RE: **P.Z. 04-2018 West County Acres, Nardin Drive (R-2, PC to R-4):** A request for a zoning map amendment from an “R-2” Residence District and “PC” Planned Commercial District to an “R-4” Residence District for a 20.7 acre tract of land located north and east of Swingley Ridge Road east of its intersection with Chesterfield Ridge Center Dr. (18S510164, 18S510142, 18S510131, 18S510119, 18S510098, 18S510229, 18S510021, 18S230158, 18S510010, 18S150043, 18S510087, 18S510108, 18S510120, 18S510153, 18S510175).

Planning Commission Vote Report

Petition: **P.Z. 04-2018 West County Acres, Nardin Drive (R-2, PC to R-4)**: A request for a zoning map amendment from an “R-2” Residence District and “PC” Planned Commercial District to an “R-4” Residence District for a 20.7 acre tract of land located north and east of Swingley Ridge Road east of its intersection with Chesterfield Ridge Center Dr. (18S510164, 18S510142, 18S510131, 18S510119, 18S510098, 18S510229, 18S510021, 18S230158, 18S510010, 18S150043, 18S510087, 18S510108, 18S510120, 18S510153, 18S510175).

Re: P.Z. 04-2018 West County Acres, Nardin Drive (R2, PC to R4)
(Stock Project No. 217-6103)

Proposed Landscape
SCALE 1"=40'

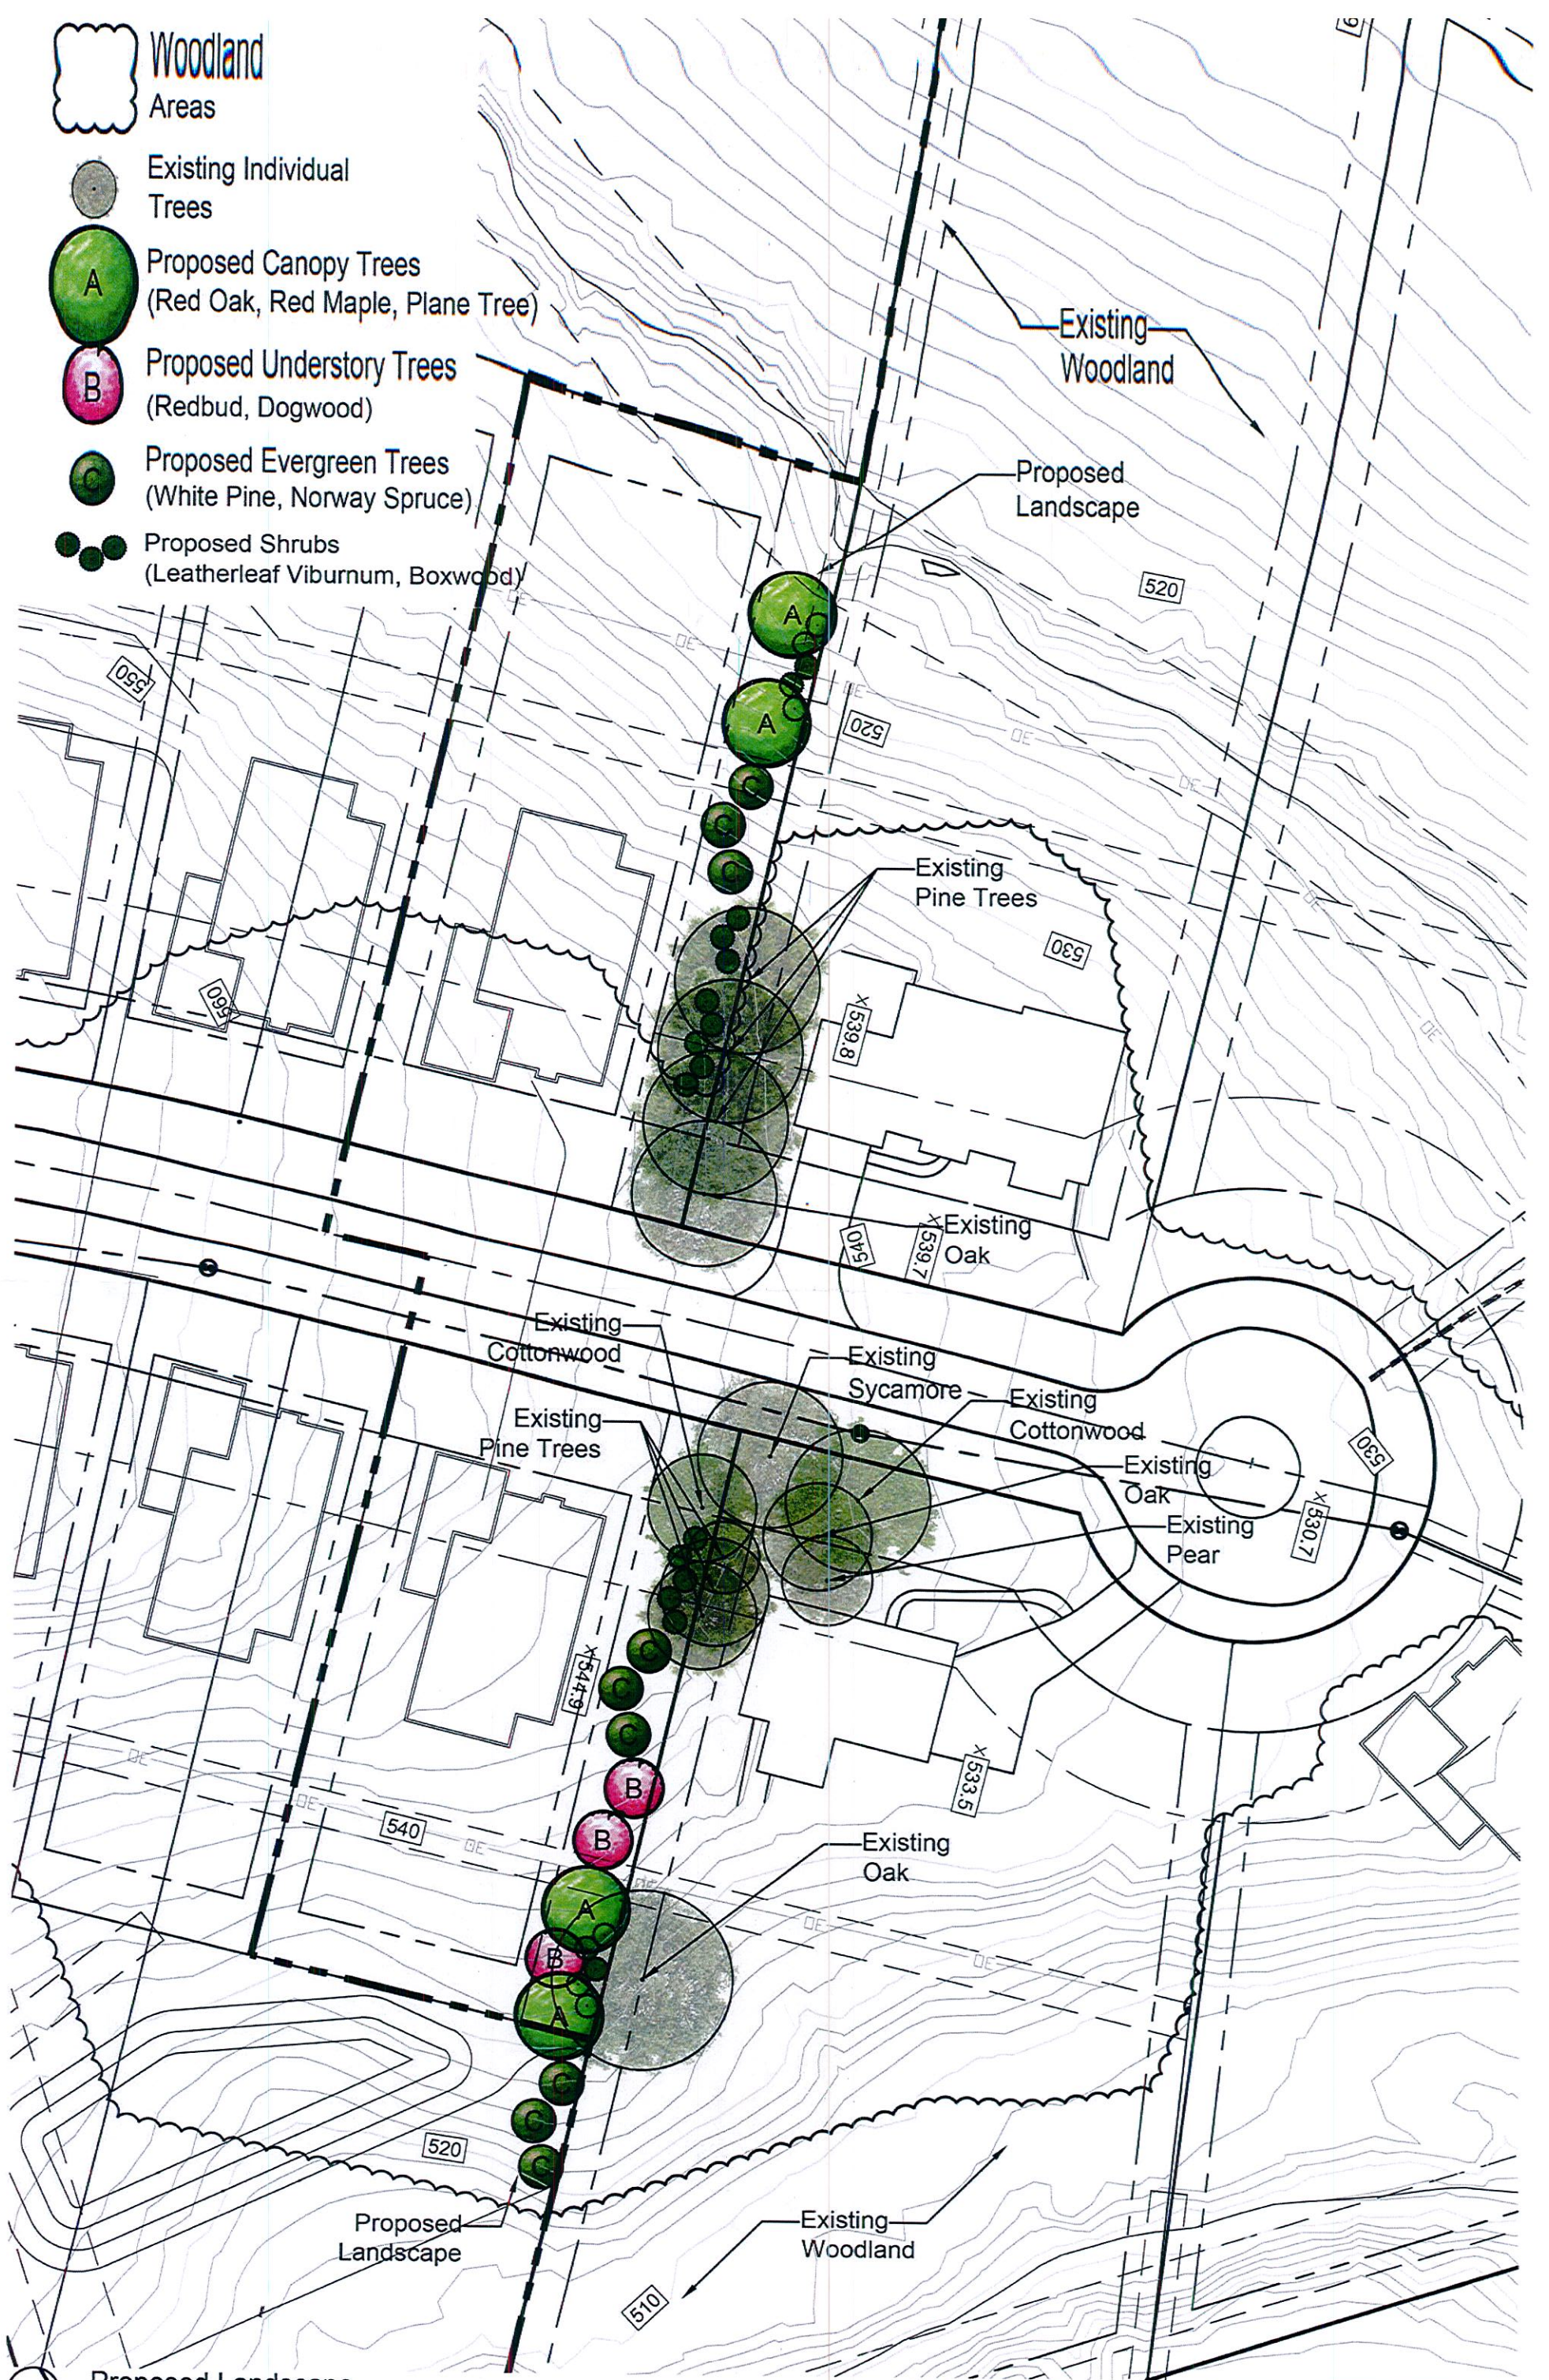
1. Transition of residential zoning districts: The Commission expressed a desire to see a transition of zoning districts to ensure that the character of existing homes north of the subject site is preserved.

Response: The proposed Two (2) Lots along the Southside of Existing Lots 19 & 23 will remain R2 Zoning. (See Revised Boundary Survey & Legal Description). A 20ft. landscape buffer will be provided along the southsides of existing Lots 19 & 23. The 20ft. landscape buffer will be a Landscape Easement on proposed Lots 21 & 22 in accordance with article 04 of the City's UDC pages 04-25 and 26.

Tree Stand Delineation
SCALE 1"=100'

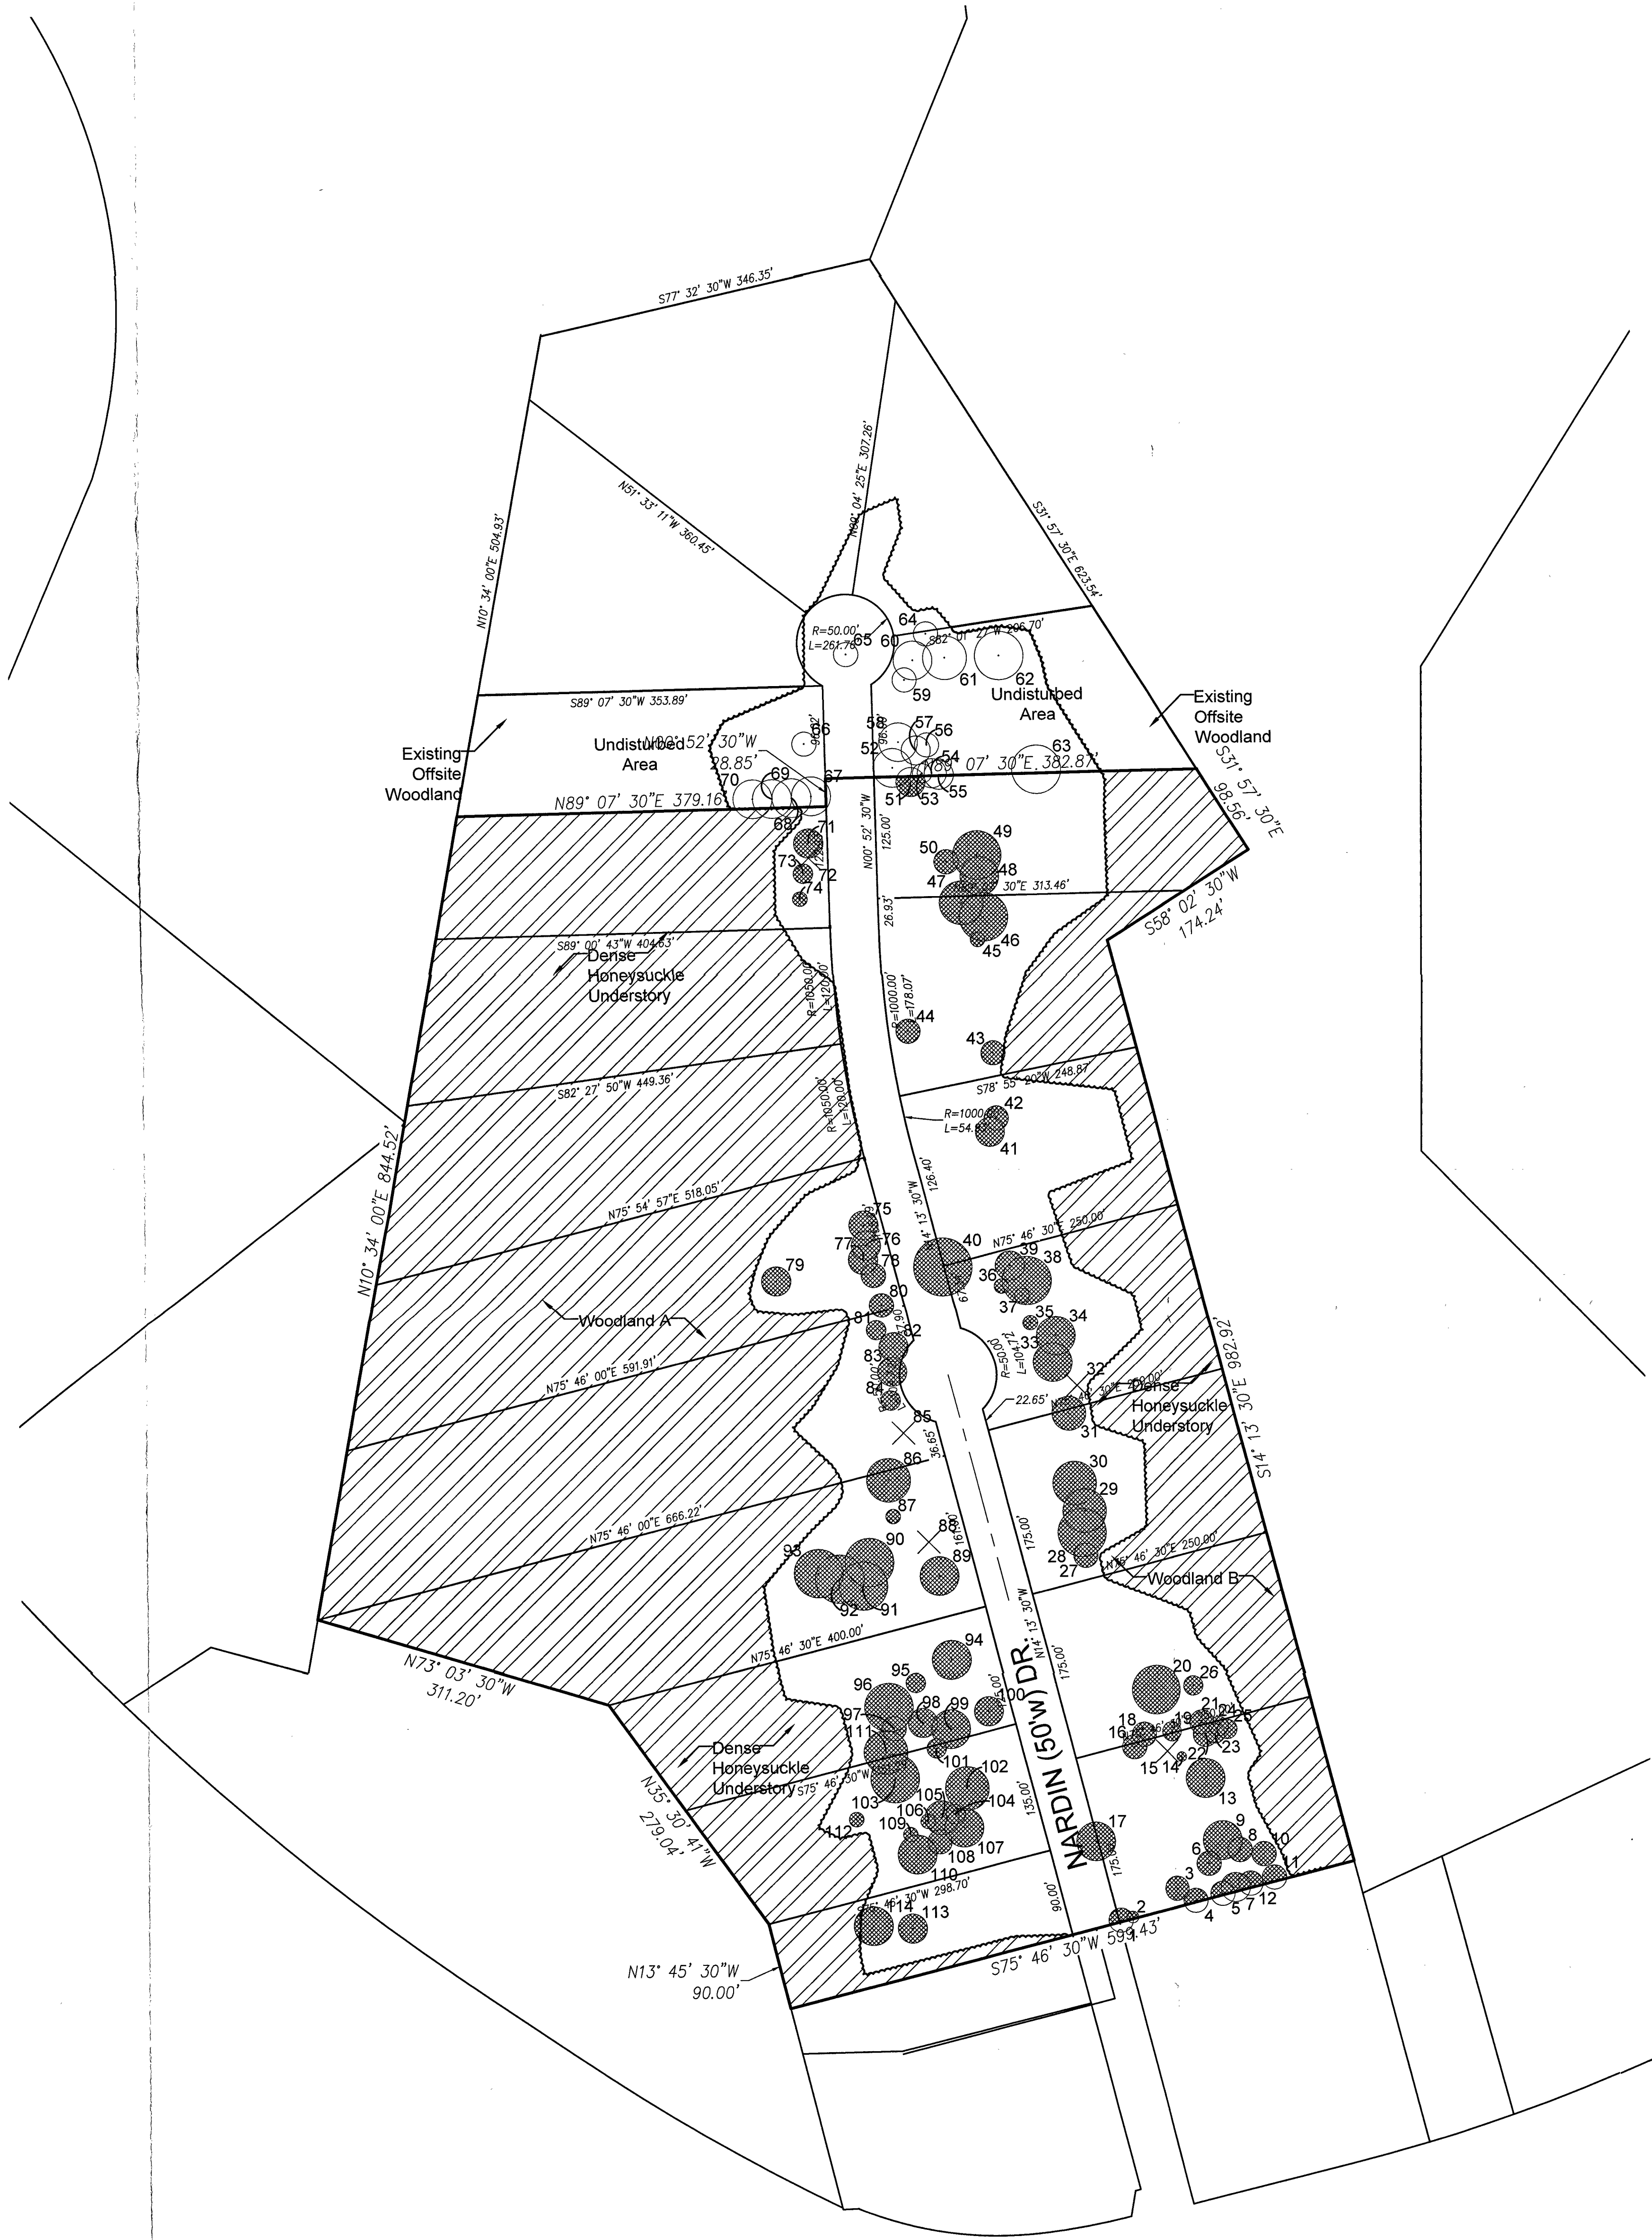
2. Consideration of Monarch Tree preservation: The Commission expressed a desire to see the monarch trees on the site preserved. Provide information about how tree preservation will be approached.

Response: We have reviewed the location of the four existing (4) Monarch Trees. They are located in close proximity to Nardin Drive. In order to reconstruct Nardin Drive to conform to the City of Chesterfield Horizontal and Vertical Alignments Standards, grading and widening will be required. Nardin Drive is currently 18-20 feet wide. The street will be replaced with a 26 feet wide street & sidewalks on each side of the street. It is unlikely "all" the trees can be saved, substantial tree canopy on Lots & around the perimeter of the lots will remain undisturbed as part of the project.
